REPORT TO COUNCIL

Application: Z15-0046 **Owner:** Unico One Developments Ltd., Inc.No. BC0990537

Address: 125 Dundas Rd
815 Hwy 33 W **Applicant:** BlueGreen Architecture (Wendy Rempel)

Subject: Rezoning Applications

Figure 1: Setback Variance

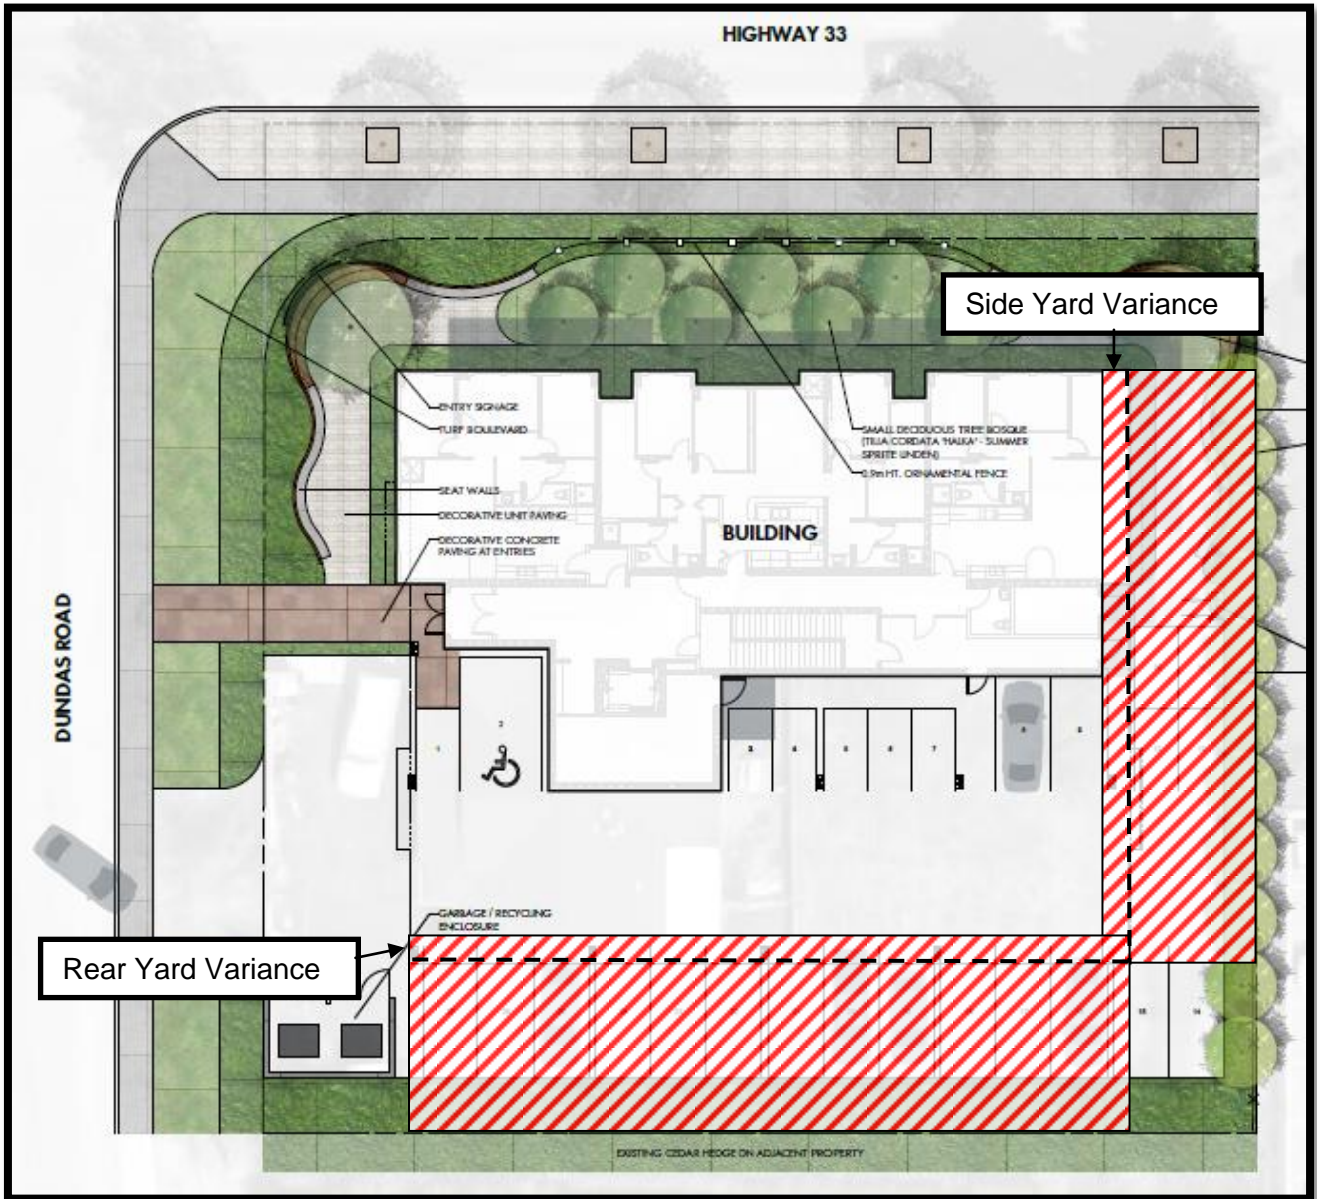
A large number of variances are currently proposed. These variances are necessary for the applicant to meet their density objectives on a relatively small site. One problem is, the applicant wants to achieve their maximum FAR identified in the zone but any plan respecting the appropriate setbacks, height, and parking requirements would not achieve the maximum FAR. As a result, the applicant is making an argument that the type of anticipated occupants (students) warrant the type of variances proposed. The applicant has been repeatedly informed that Staff cannot recommend support for a parking variance (regardless of the car-share mitigation proposal) when the subject property falls within a cash-in-lieu area. Further, in order for Staff to consider a recommendation of support (regarding the variances) the applicant has been informed that cash-in-lieu for the parking shortfall as well as a car-share program would be necessary to mitigate the shortfall. However, Staff will provide further details on the merits of the variances and details of the development proposal within the Development Permit and Development Variance Permit report should Council choose to adopt the zoning on the site.

- 1) Side yard setback reduction requested (from 7.0m to 5.2m);
- 2) Rear yard setback reduction requested (from 9.0m to 7.1m);
- 3) Site coverage reduction requested (from 40% to 43.05%);
- 4) Eleven (11) parking stall reduction requested and 8 stalls paid by cash-in-lieu;
- 5) Requested an increase in the proportion of small vehicle size stalls (from 10% to 37%);

- 6) Class 1 bicycle parking location variance requested (from the bicycle parking must be located at building grade or within one storey of building grade to the third storey);
- 7) Private open space reduction requested (from 575m² to 356.2m²).
